Fort Calhoun Station, Unit No. 1
Renewed Facility Operating License No. DPR-40
NRC Docket No. 50-285

SUBJECT: Emergency Plan Update

REMOVE SECTION	INSERT SECTION
EP-FC-1001 Addendum 3 Rev 2 issued 11-22-16	EP-FC-1001 Addendum 3 Rev 3 issued 12-29-16

Level Indication Figure from EC55864

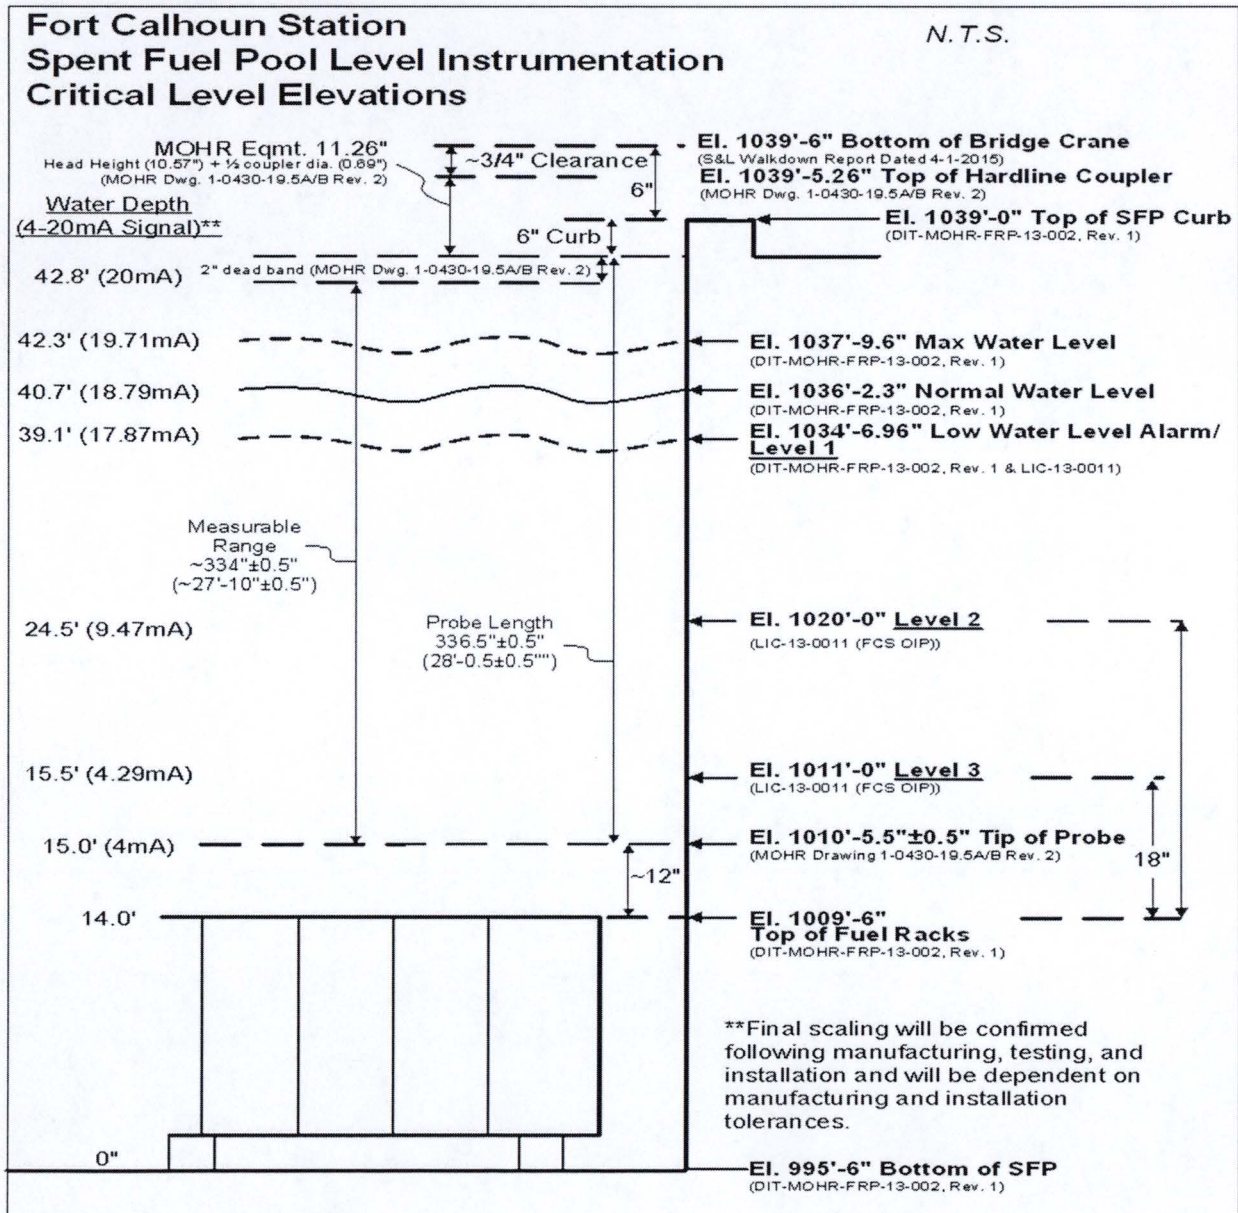
EC55864 installs two new instrumentation systems, primary and secondary, to measure the SFP level, and meet the requirements set forth in NRC Order EA-12-051.

- Level 1: 1034'-6.96" (39.1' of pool depth above pool floor, same level as existing low pool level alarm)
- Level 2: 1020'-0" (24.5' of pool depth, level selected to be 10.5' above top of fuel racks)
- Level 3: 1011'-0" (15.5" pool depth, level selected to be 1.5' above top of fuel racks)

This Figure identifies the instrument range relative to the FCS fuel pool elevations and critical levels required to be monitored in accordance with NEI 12-02. The instrument range of the system, including the dead zone of 2" at the top of the probe (Ref. MOHR Drawing No. 1-0430-19.7A), encompasses the maximum water level down to level approximately 12 inches above the fuel racks. The figure demonstrates that the instrumentation range at the installed elevation is adequate to measure the critical levels required for this application.
